REMARKS

DRAWING AMENDMENTS

Applicants respectfully request amendment of figures 6B and 8C.

Figure 6B

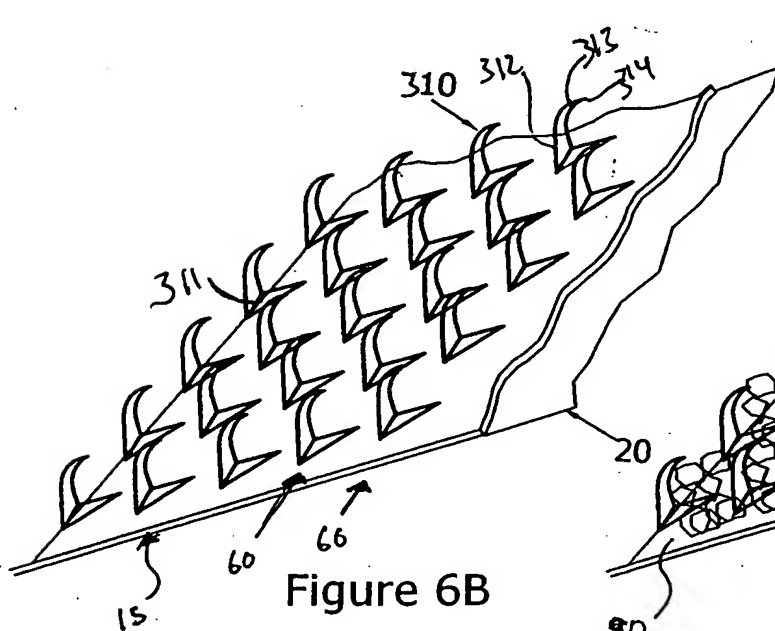
Applicants request amendment of figure 6B to change: reference
number 11, to reference number 311; reference number 12, to reference
10 number 312, reference number 13, to reference number 313; reference
number 14, to reference number 314, as described in the specification at
paragraph 69.

Figure 8C

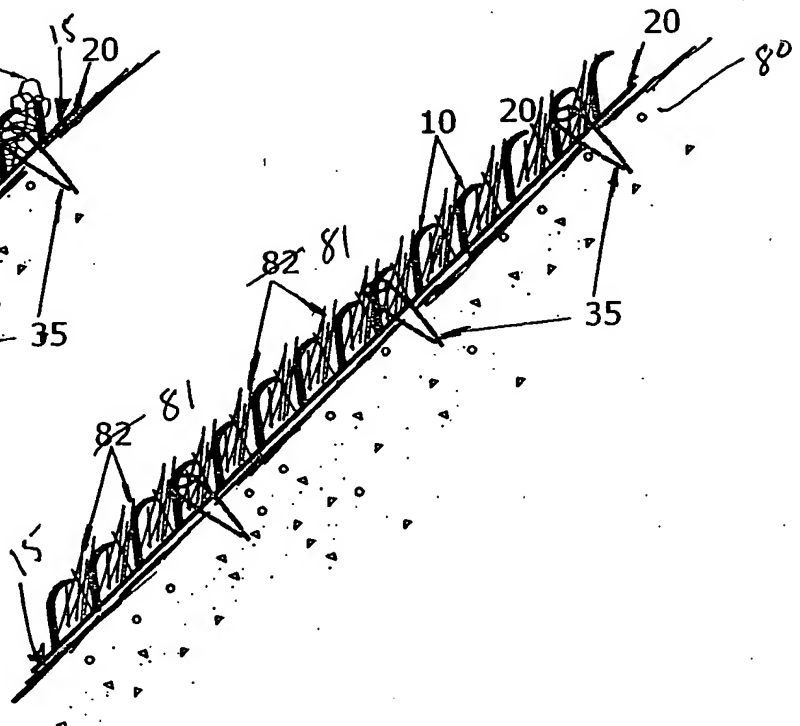
Applicants request amendment of figure 8C to change reference
number 82 to 81, as described in the specification at paragraph 95.
